STORM SEWER PROFILES

WOODBURY PLACE

ST. CHARLES COUNTY, OTTAWA, MISSOURI

Sheet: C106

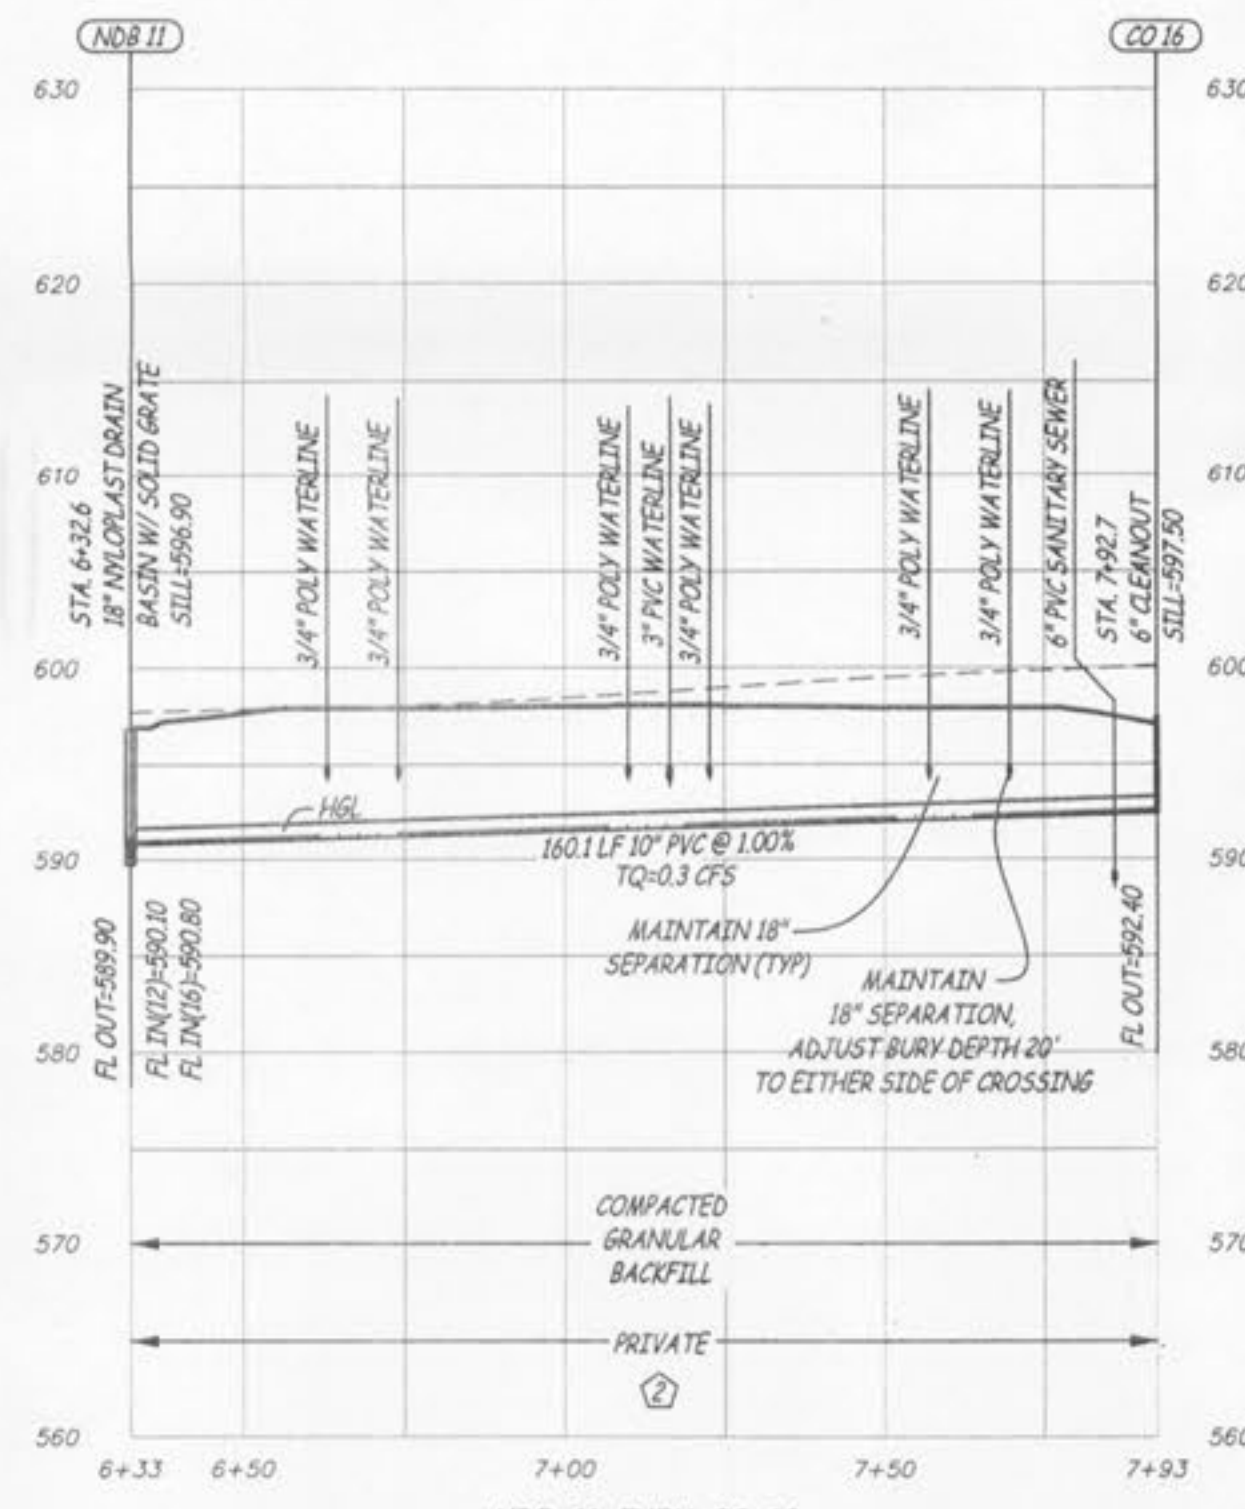
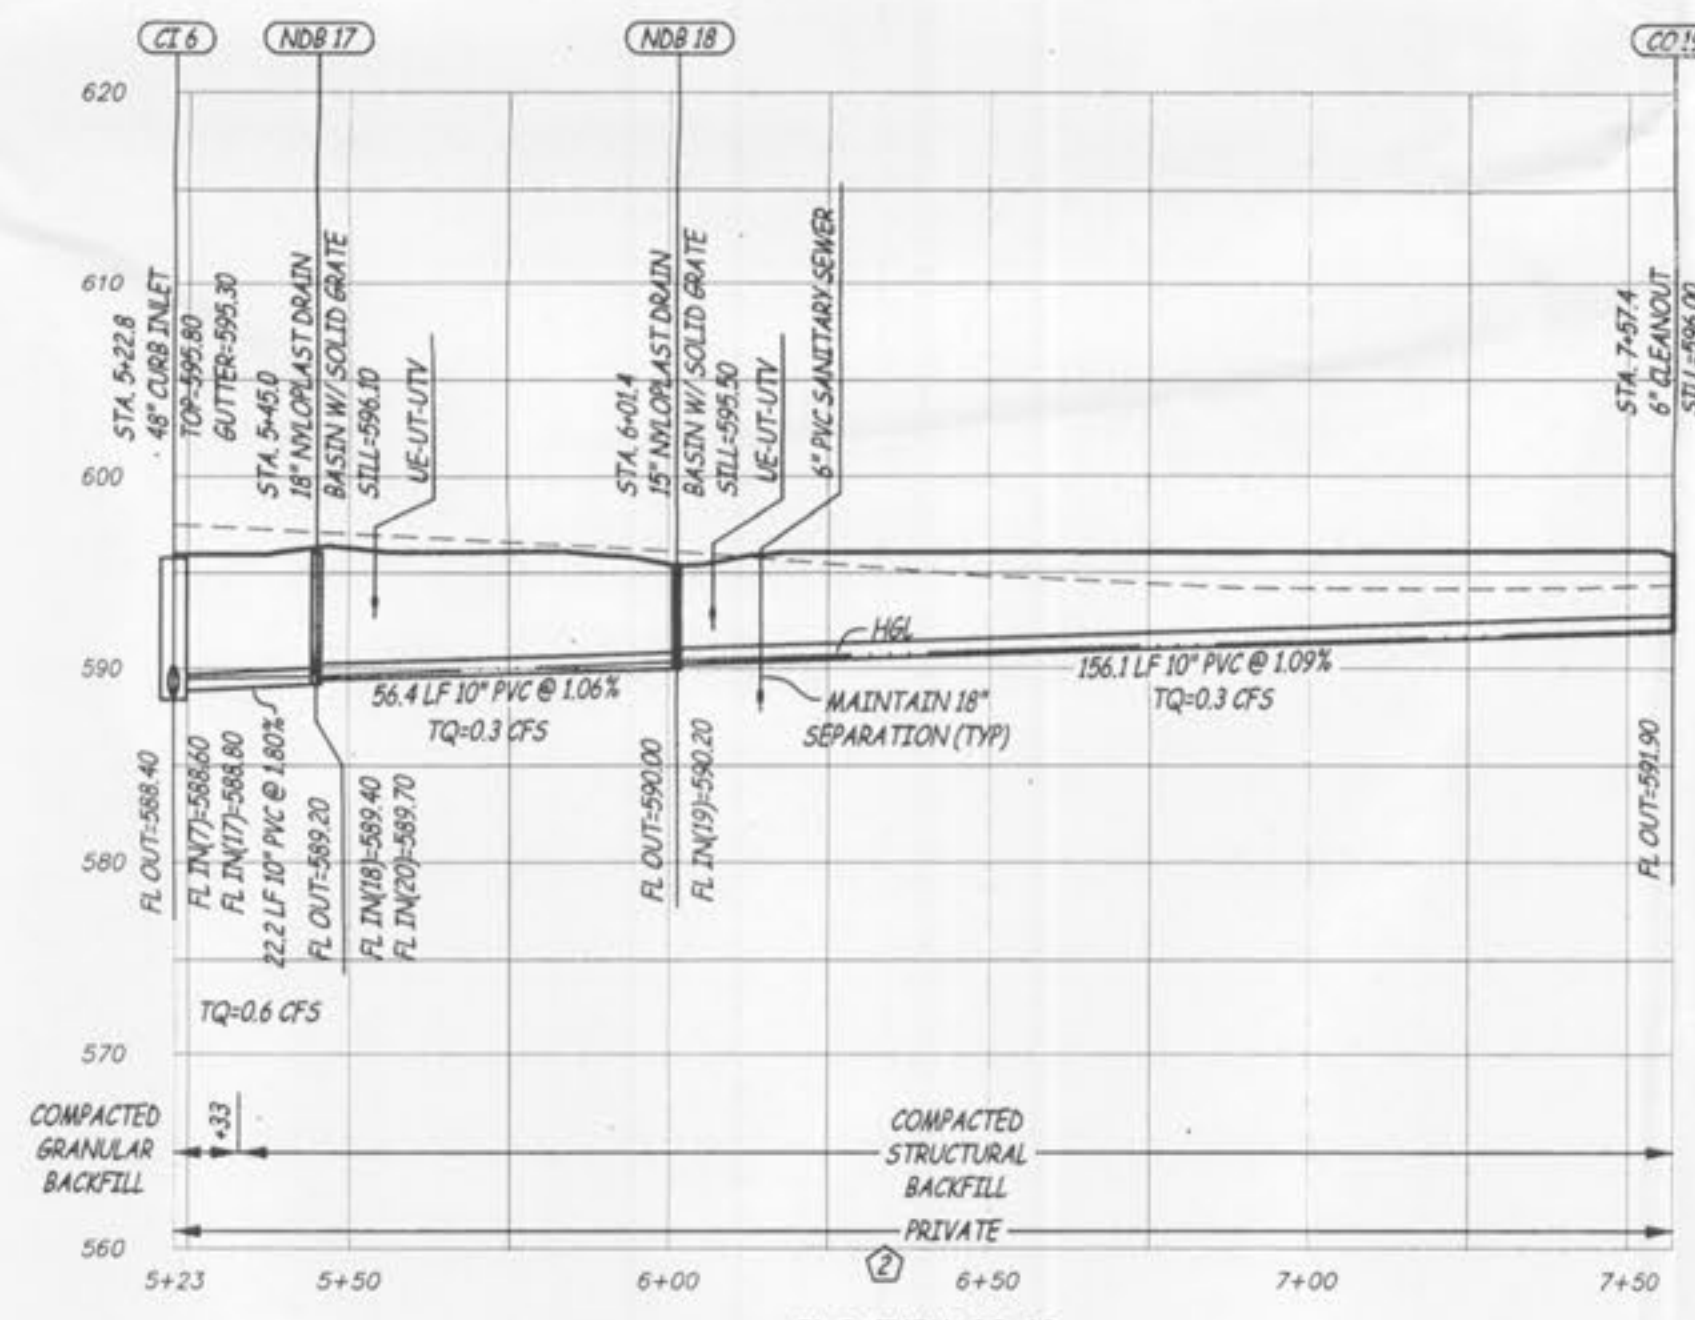
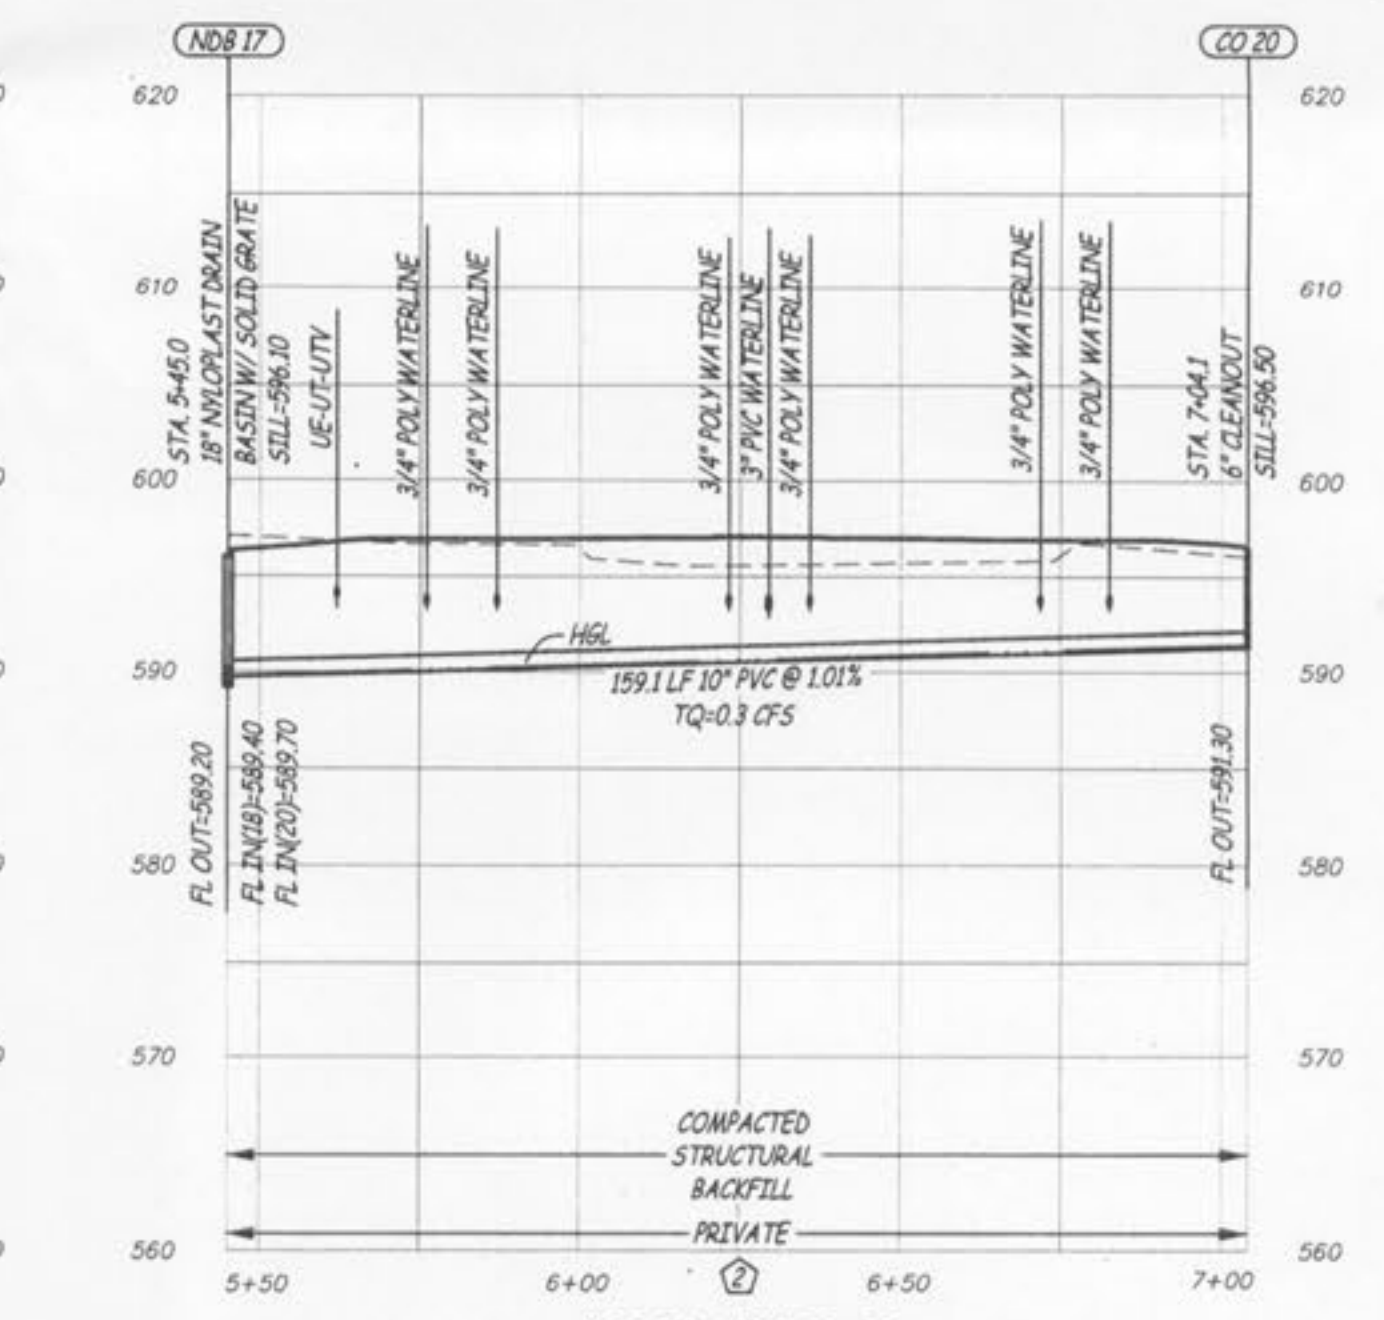
1. NDB 15 & 24 REVISED TO 10" NID
2. EXTENDED EX. CB THRU CI 8 TO INCLUDE THE NEXT 2 DOWNSTREAM MANHOLES
3. ADDED "PUBLIC" AND/OR "PRIVATE" NOTES TO ALL STORM SEWER PROFILES
4. MOVED PROFILE FOR MH4 THRU CO 26A TO ANOTHER SHEET
5. REVISED "PUBLIC" LINE ON "EXISTING MANHOLE THRU CI 8" PROFILE
6. RELOCATED WATERLINE ALONG WOODLAWN AVENUE
